# Notice of Modification

## Section 96(2) of the *Environmental Planning and Assessment Act 1979*

The development consent (SSD 5144) for the Mandalong Southern Extension Project, granted by the Planning Assessment Commission, as delegate of the Minister for Planning on 12 October 2015.

Figure 2: Approved Mine Plan

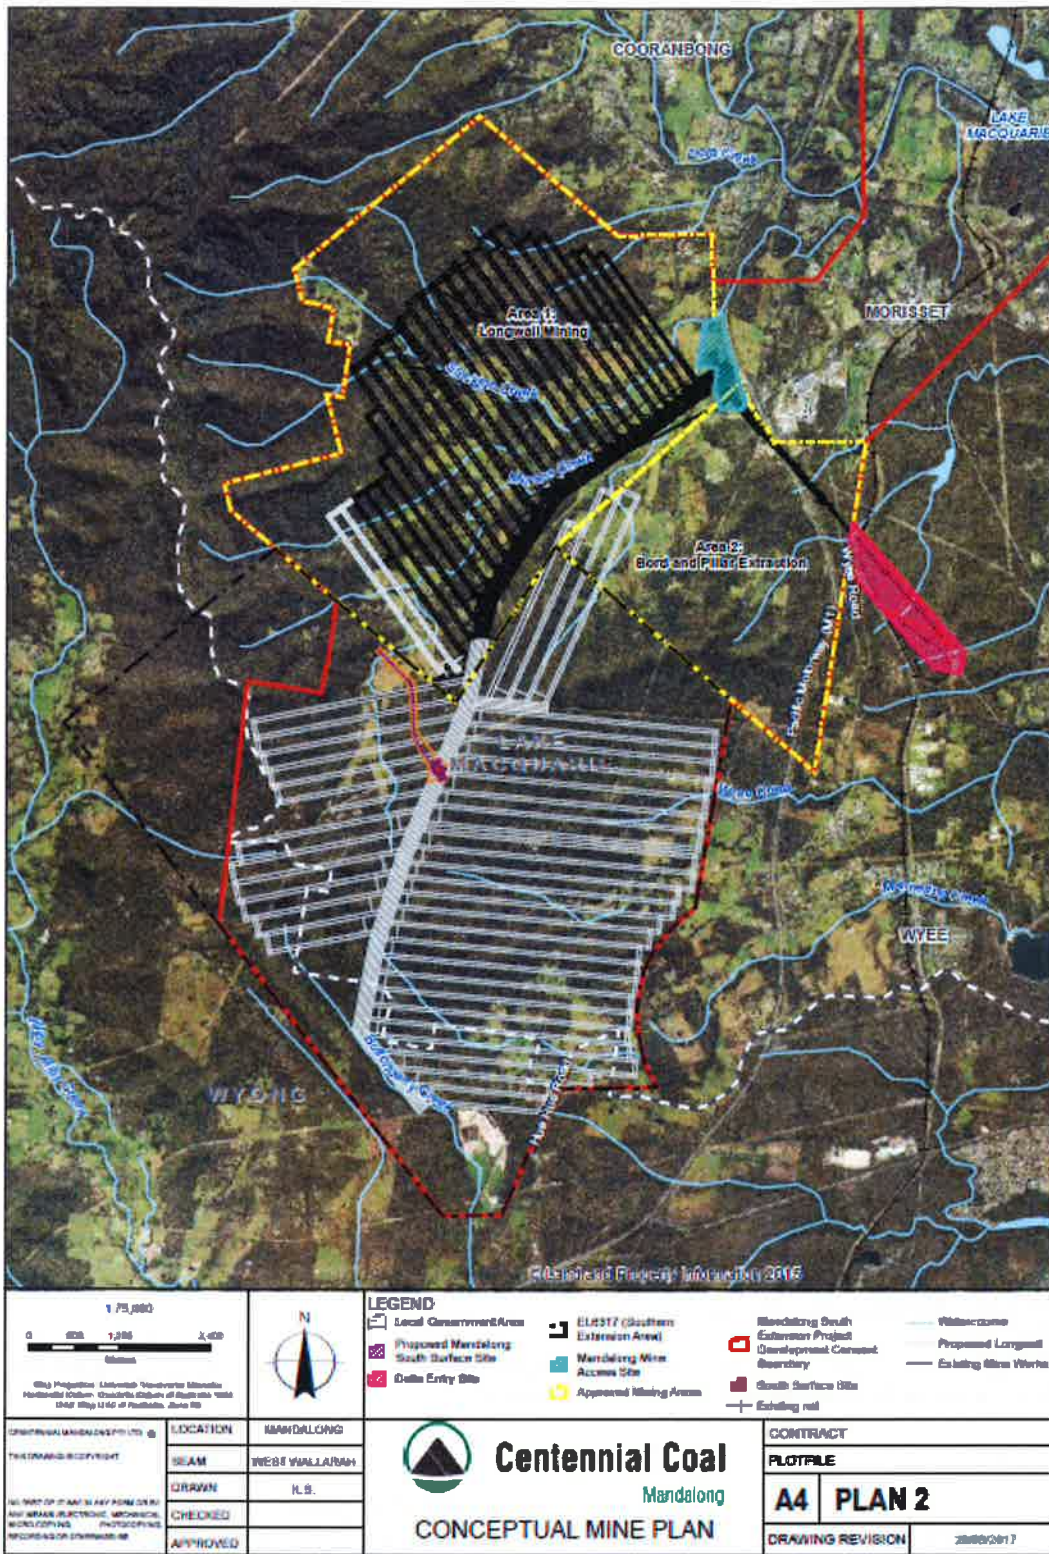
The review must be undertaken and reported to the satisfaction of the Secretary. The report must be submitted to the Secretary and DPI Water prior to the approval of any Extraction Plan relating to Longwalls 24 and/or 24A.
6. In condition 8(a) of Schedule 4, delete the words "EIS and SEE (Mod 4)" and insert "documents listed in condition 2(b) of Schedule 2".
7. In Appendix 2, delete Figure 2 and insert the following:
